Region III Written Examination and Operating Test Comments

The following is contained in this package:

ES-401-9 Written Examination Review Worksheet (1 worksheet for RO & SRO examinations). Written examination with comments. Operating Test with comments.

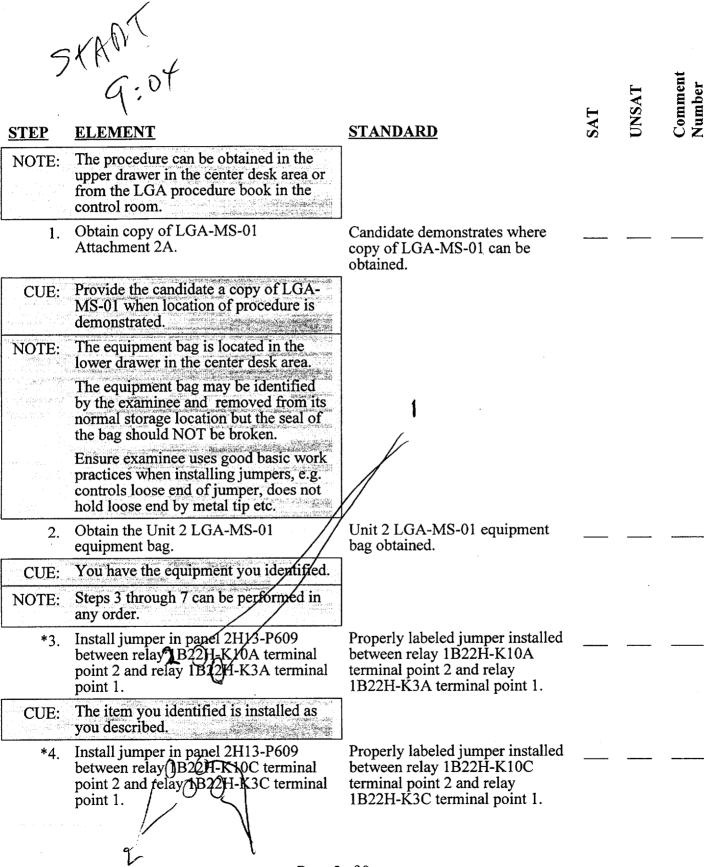
Need ANSwer key (NARS Form)
